BP-15139-A

Minor Change Request

for revisions to previously issued permits

EXHIBIT D-1 SITE PLAN

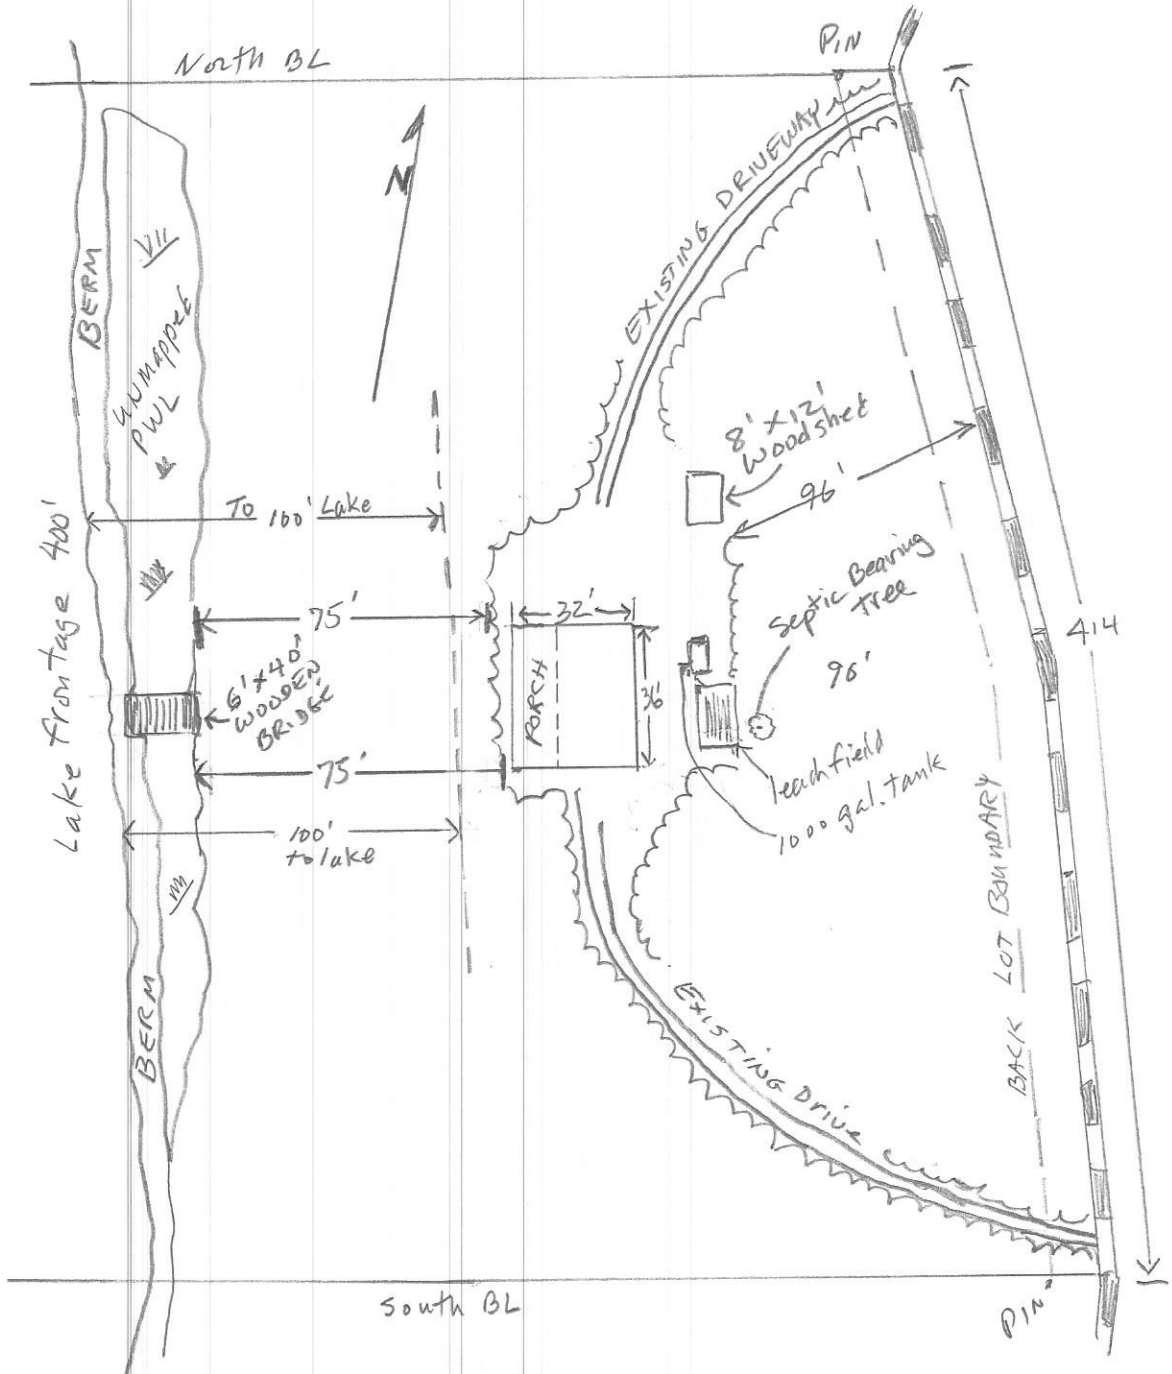
- 1) New Septic Design (attached): Note Septic field in exact location as original submission but slightly smaller. Causes cabin location to be slightly different.
- 2) Fill: Cabin foundation is slightly higher (1') Expect to bring in 200 yards of clean fill to be placed next to foundation.
- 3) change cabin dimension size from 36'x30' to 36'x32'.

SUBSURFACE WASTEWATER DISPOSAL PLAN

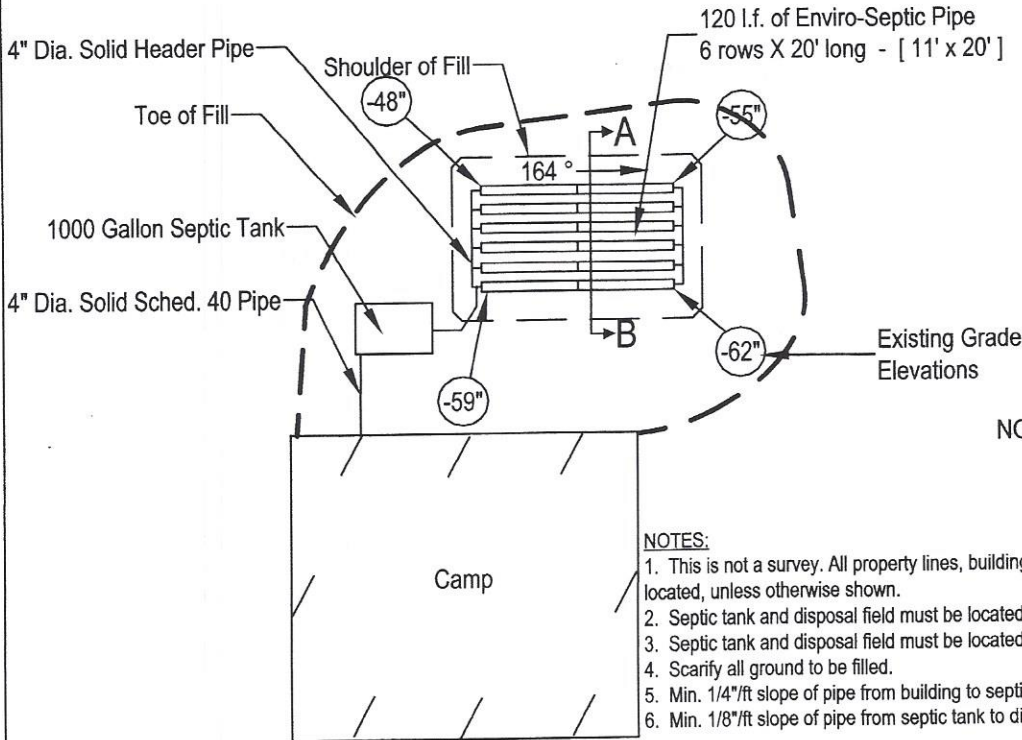
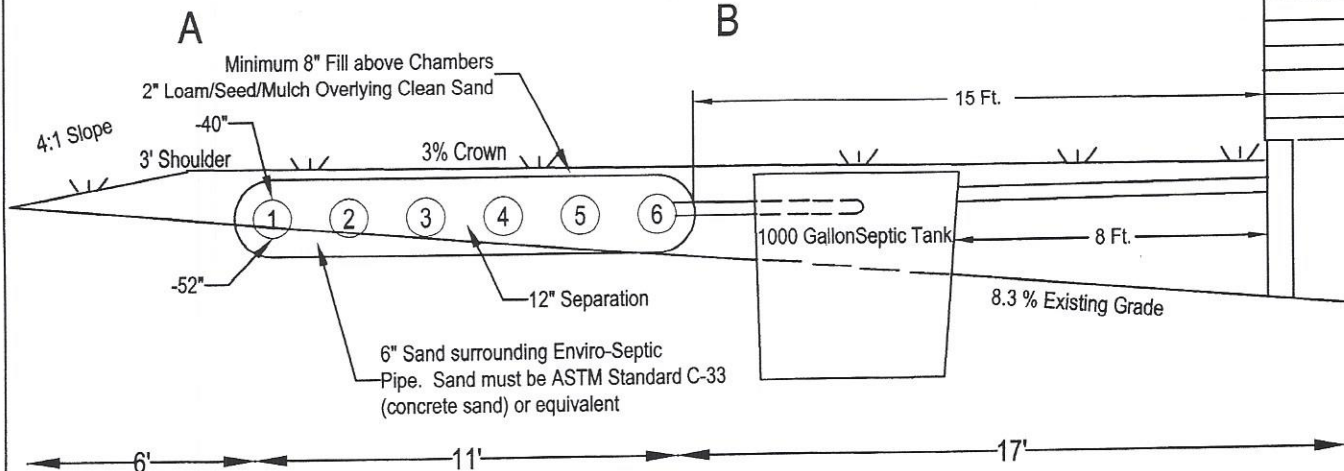
DEEPER FILL NEEDED FOR X-SEC SHOWN BELOW
